File            SPR-1995-037

Project Name: Cottonwood Mall

TITLE HEADING: Site Plan Review - Cottonwood  
Mall

FILE: #SPR 95-37  
DATE: February 24, 1995  
STAFF: Michael Drollinger  
REQUEST: Site Plan Review  
LOCATION: 2493 Hwy. 6&50 - Cottonwood Mall  
ZONING: C-2

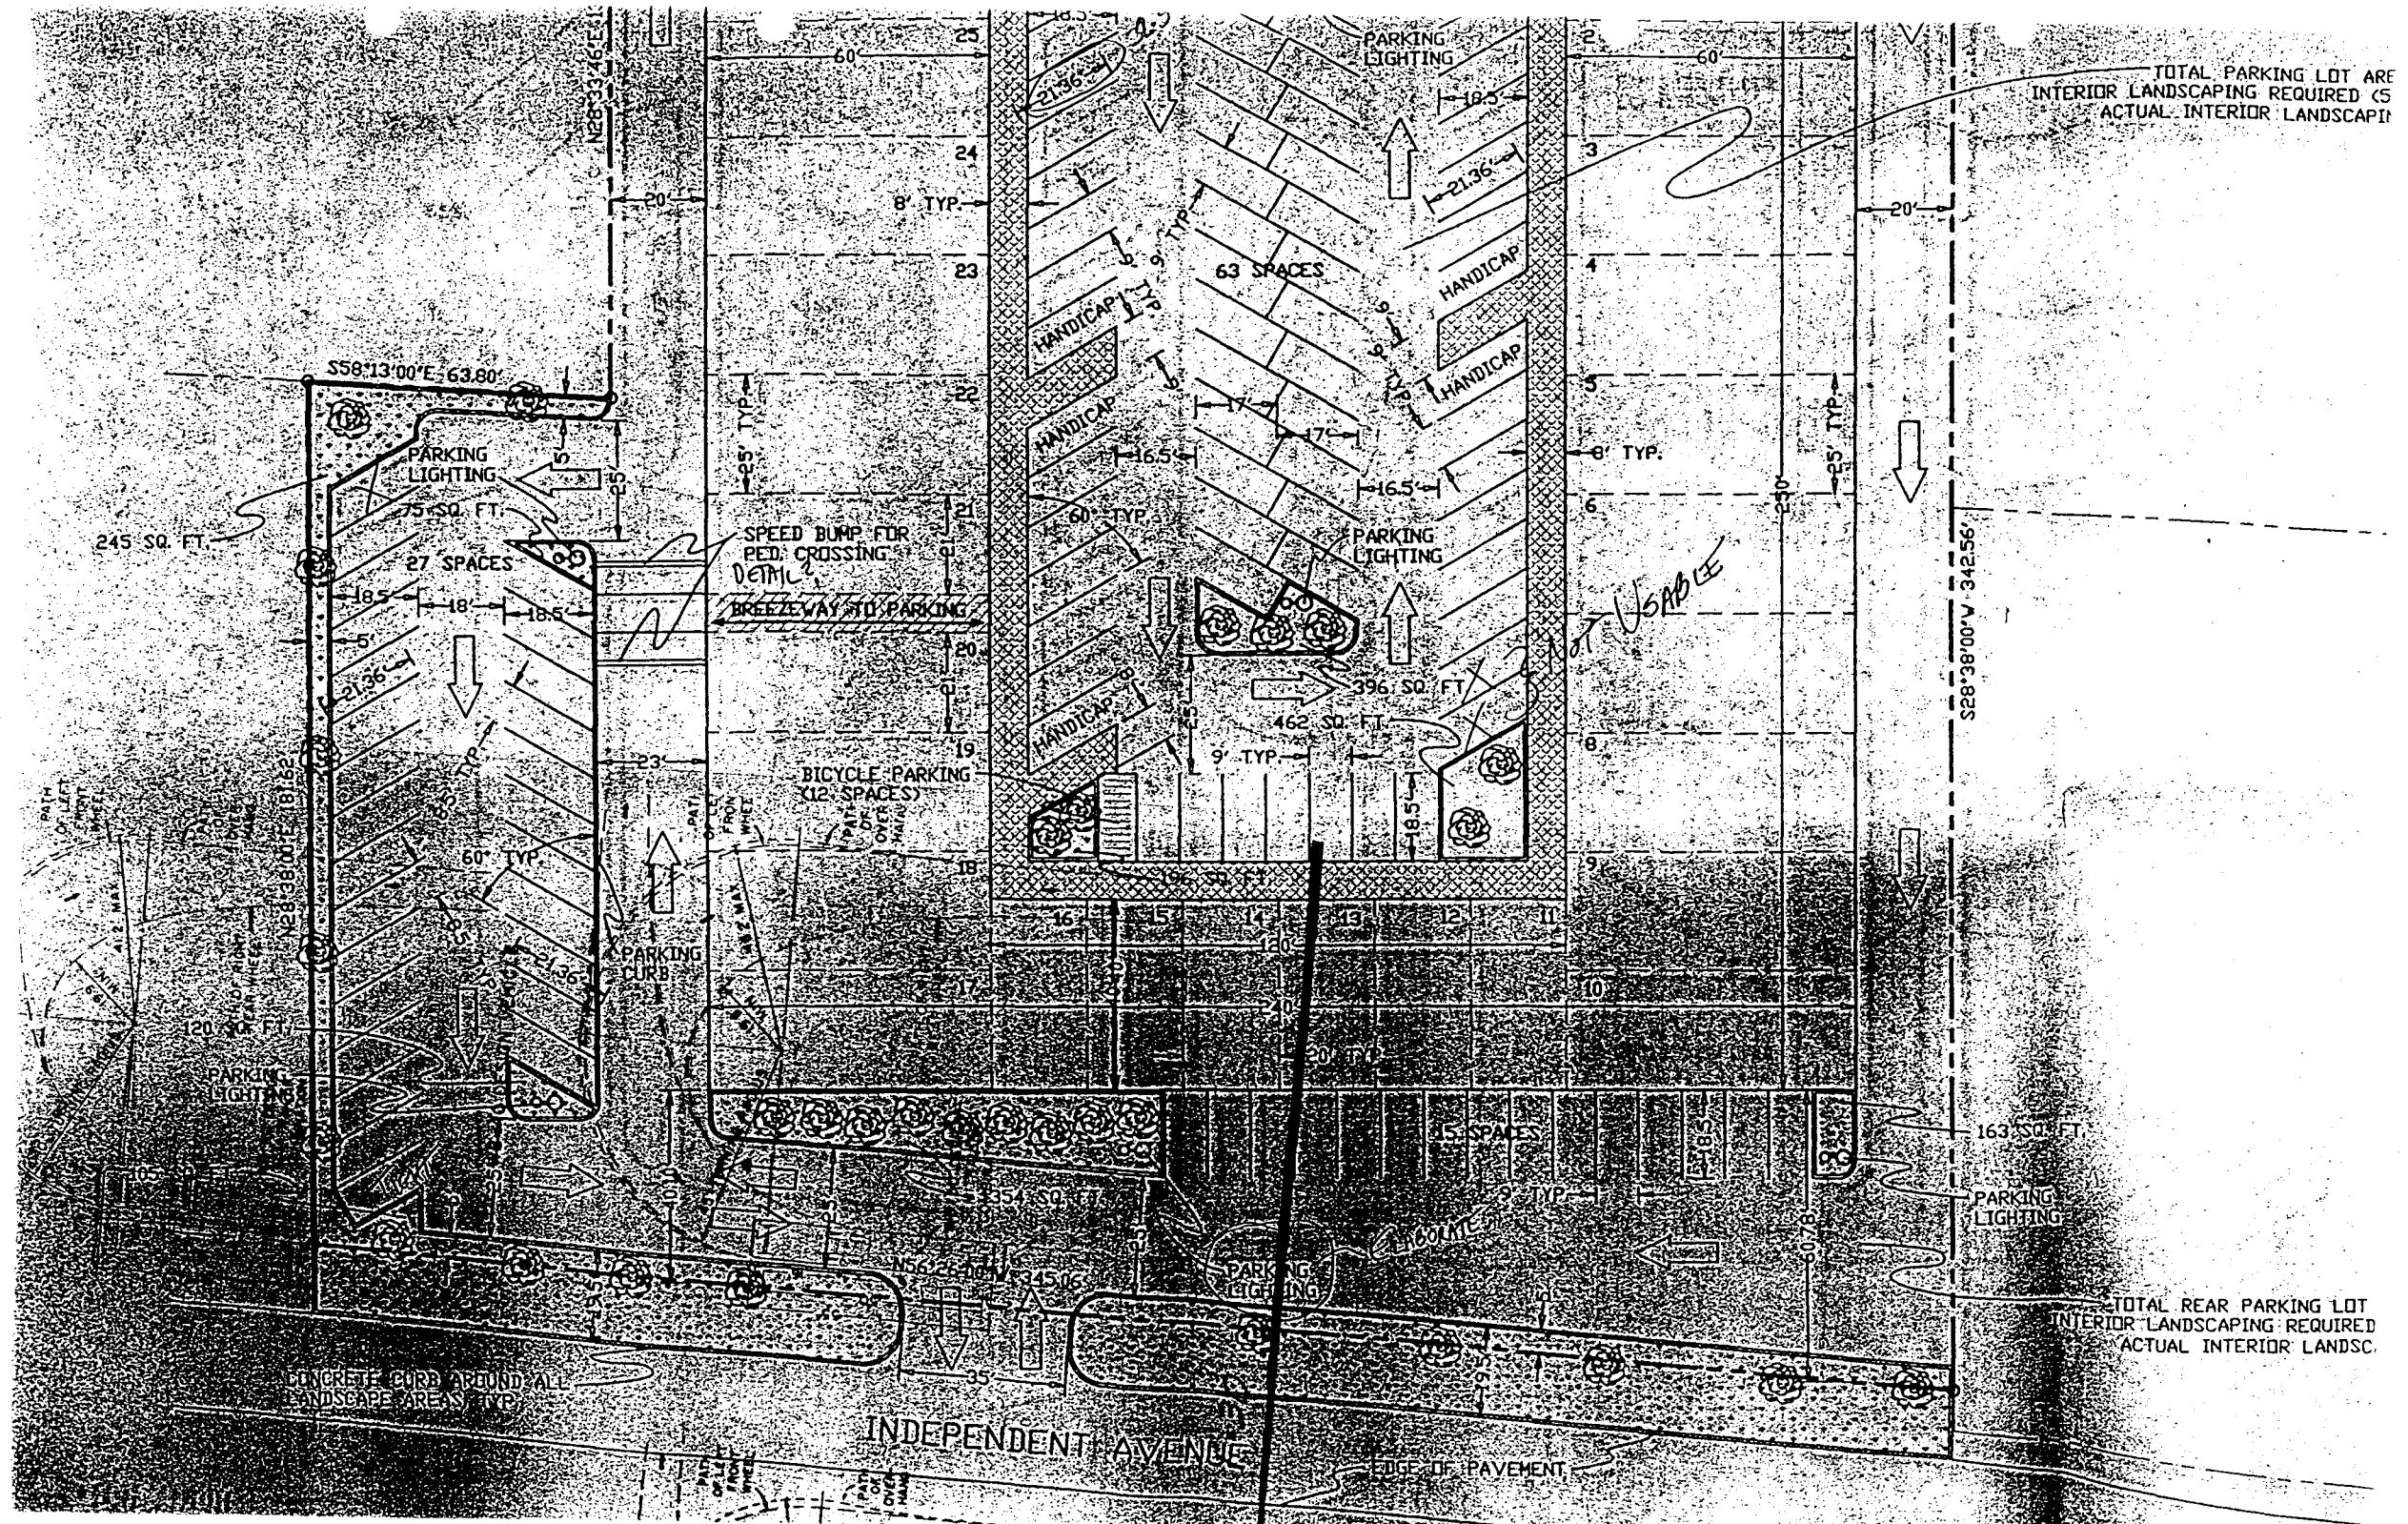
There are at least three, possibly four unusable parking spaces as shown because cars will not be able to back out without hitting other parked cars. These are marked on the redlined plans.

Please show a detail for the speed bump. I have included a copy of a speed hump which has been shown to be effective both to slow down vehicles without tearing out the bottoms of cars and provide a pedestrian crosswalk.

Please include a note and/or detail for the handicap parking spaces so that they are marked and signed appropriately. City Standard Drawings have the details. No grades are shown, but a ramp may be required from the parking lot to the sidewalk to accommodate handicapped. Maximum slope allowed is 1" rise per foot.

1. Adequate striping and signage must be provided to identify circulation patterns, especially considering the amount of one-way circulation proposed. Traffic control signage locations and details must be provided on the Site Plan as per the SSID manual.

4. Half-street improvements are not identified. Curb, gutter, and sidewalk (minimum width six feet for sidewalk) are required along the frontage road.
5. Bicycle parking rack detail required.

Please see revised plans, they should address all of your comments regarding the proposed project.

1. The questions regarding traffic flow have be resolved with Jody Kliska at Engineering. We have increased the lighting for the exterior, as per your request.
2. The speed bumps located at the pedestrian walkway will remain as shown, with or without modifications.

**APPENDIX C**  
**RETENTION BASIN OUTFLOW DESIGN WORKSHEET**

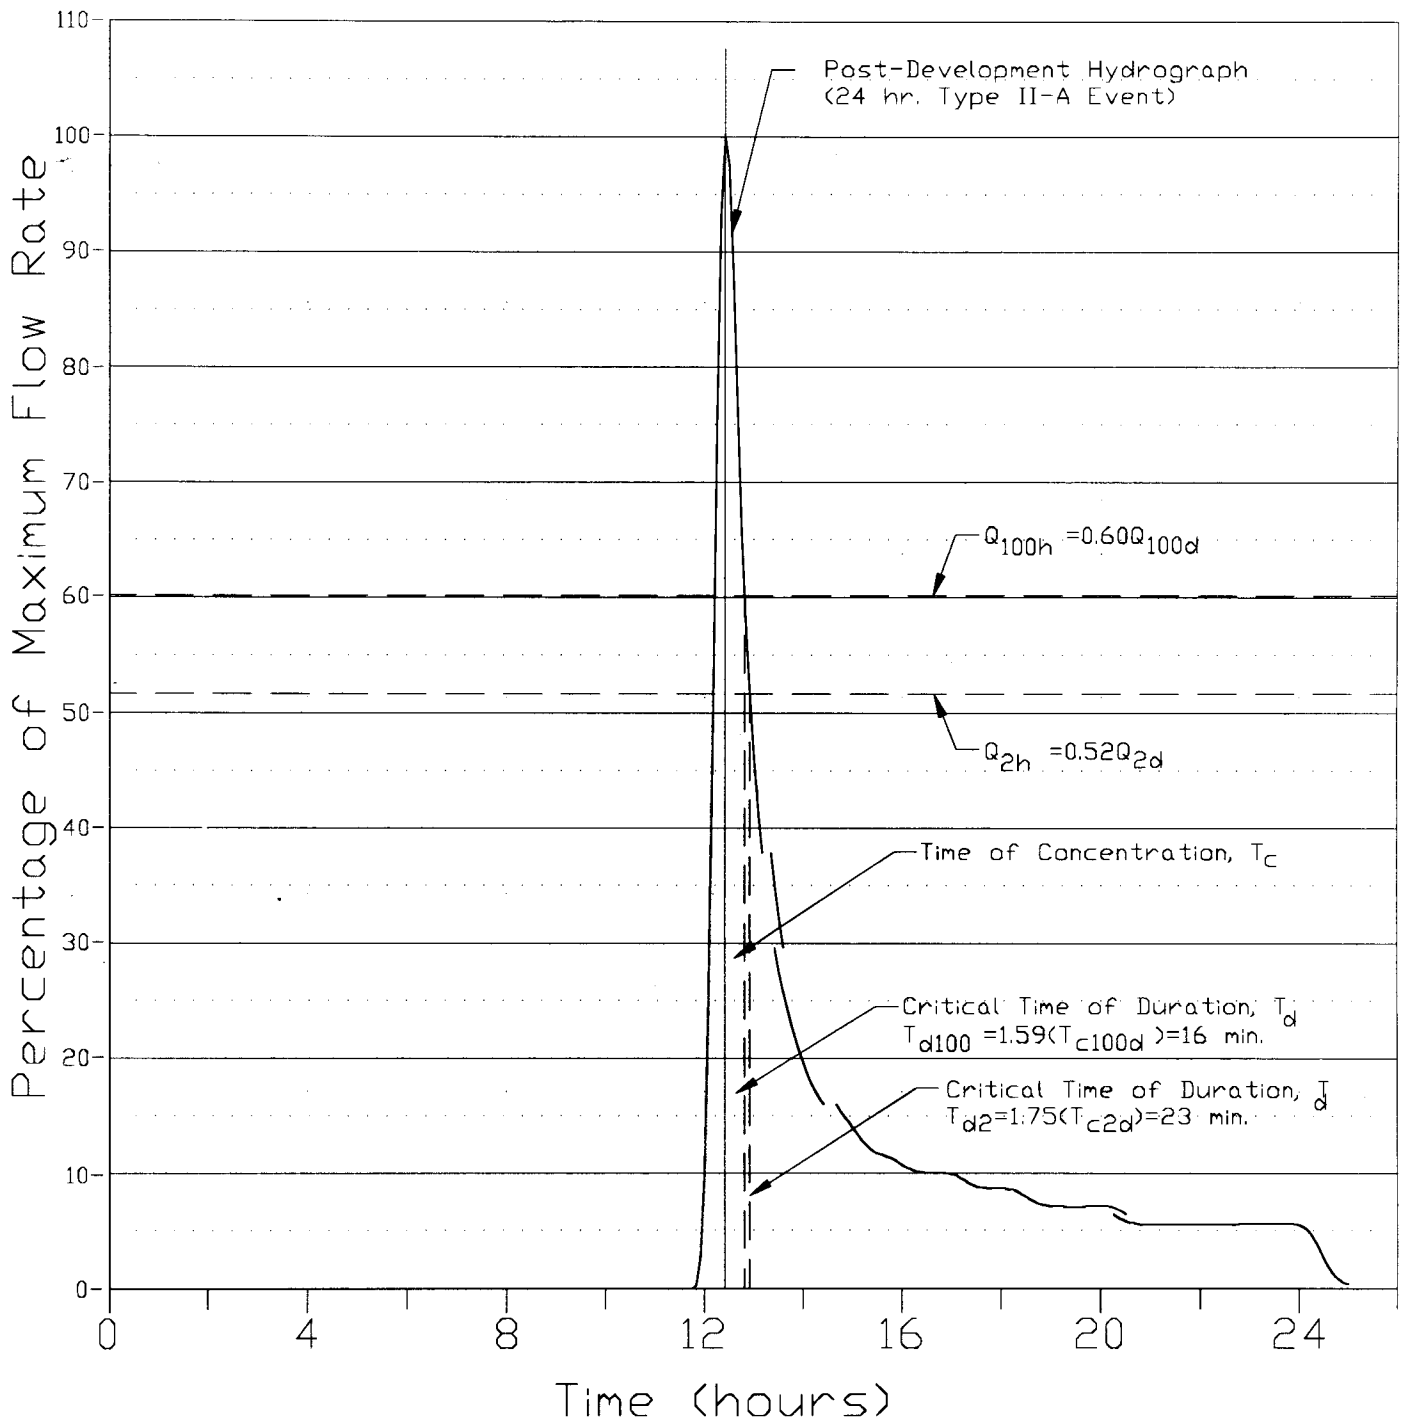
Please recheck the drainage report calculations for the outlet orifice. It appears the calculated orifice should be 1" in diameter, not 10". You may want to consider a combination weir in the wall, and release the historic 2 year and the historic 100 year flows, rather than a pipe.

CHANGE  
 TO 5.1

OF  
 0.292 FT<sup>2</sup>  
 @ 1.5 cfs  
 OR ABOUT  
 A 1" PIPE

PROJECT REFERENCE: COTTONWOOD MALL SITE PLAN  
PROJECT LOCATION: 2493 HWY 6850 GRAND JUNCTION, CO 81506  
DATE: JANUARY 31 1995  
SCALE: 1 IN = 20 FT  
PREPARED BY: TOM A CRONK

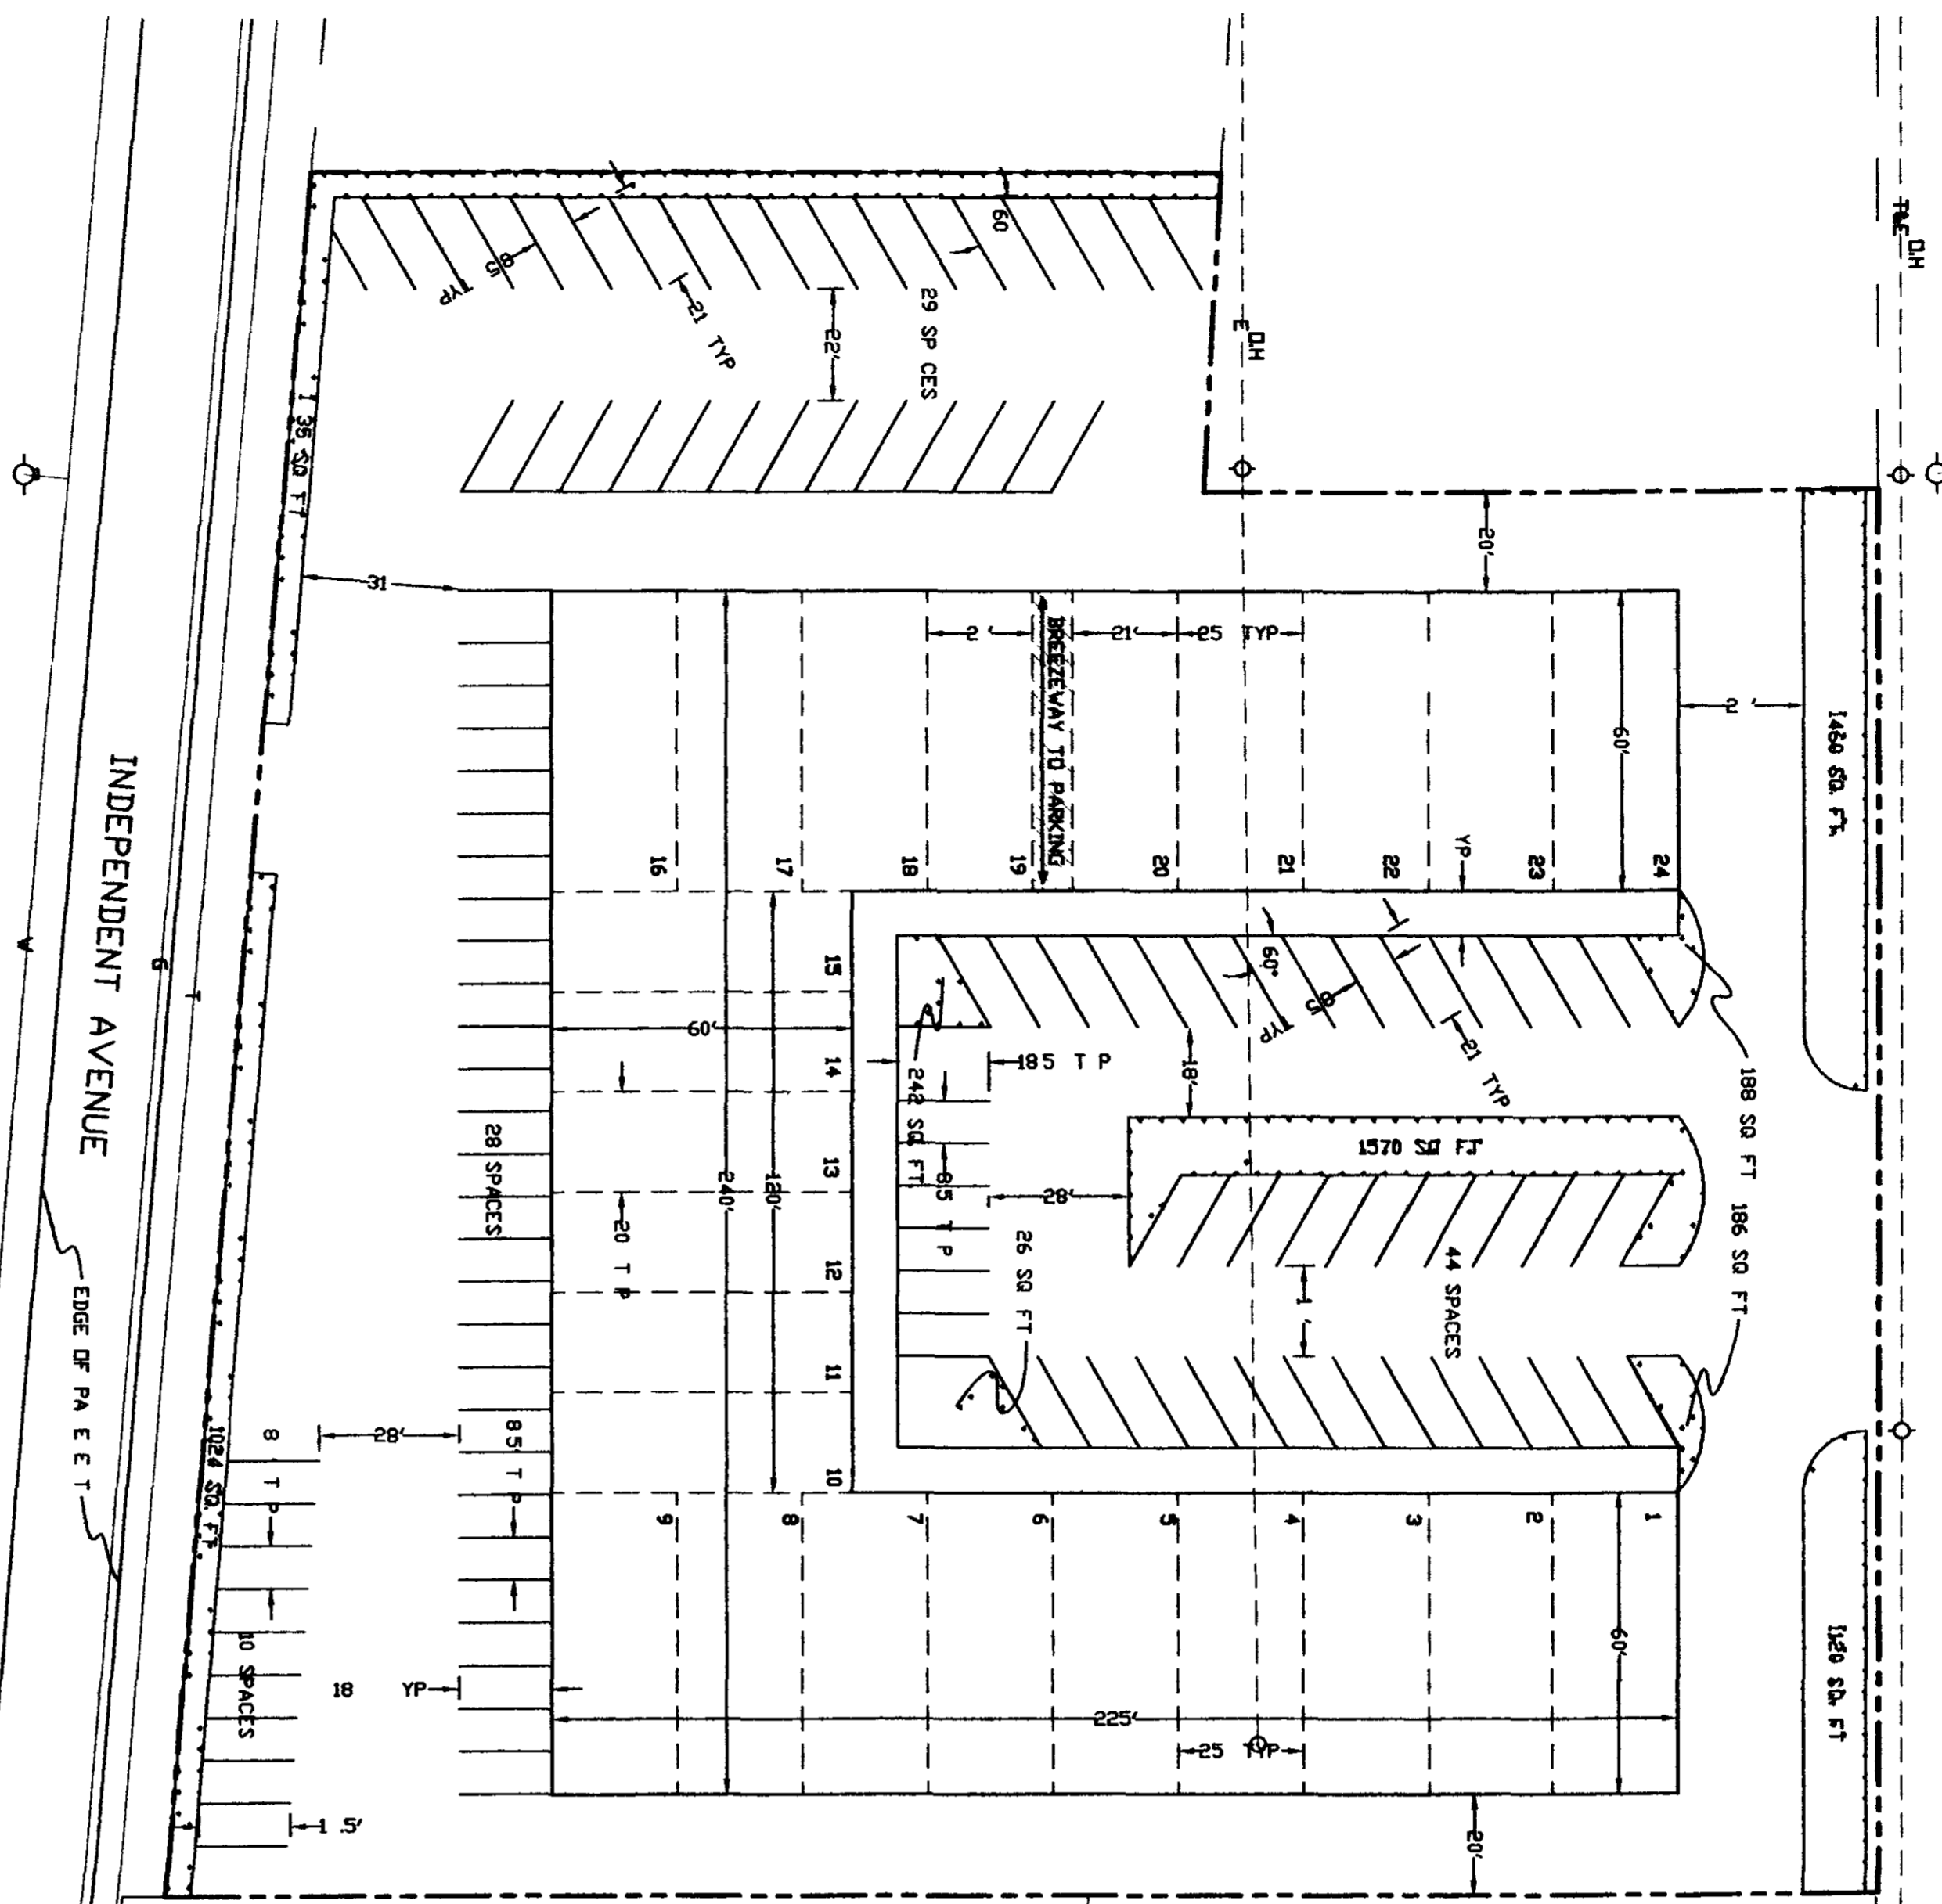
City Zoning and Development Code requires a lighting plan showing the specifications and an isofootcandle diagram. See section 5-5-1 F (2)(i).

1. Landscape Plan does not meet SSID requirements. See attached "Drawing Standards Checklist" for missing items.
2. Frontage landscaping and right-of-way landscaping appear to be adequate subject to additional detail being supplied on the Landscape Plan. A revocable permit is required for landscaping in the ROW (no charge - contact Community Development for details).
3. Street frontage landscaping adjacent to the southern parking areas does not meet the depth requirements of Section 5-5-1F2(a). The required landscape barrier is also not provided.

4. The requirements of Section 5-5-1F2(c)2 regarding protection of landscaping from vehicular encroachment have not been met.
5. Planting island width for islands in lot in southwest corner of site must be a minimum of nine (9) feet (see Section 5-5-1F(2)c3).
6. The landscaping details provided are insufficient to determine compliance with Section 5-5-1F(2)e.
7. A lighting plan and lighting details must be provided as per Section 5-5-1F(2)i.
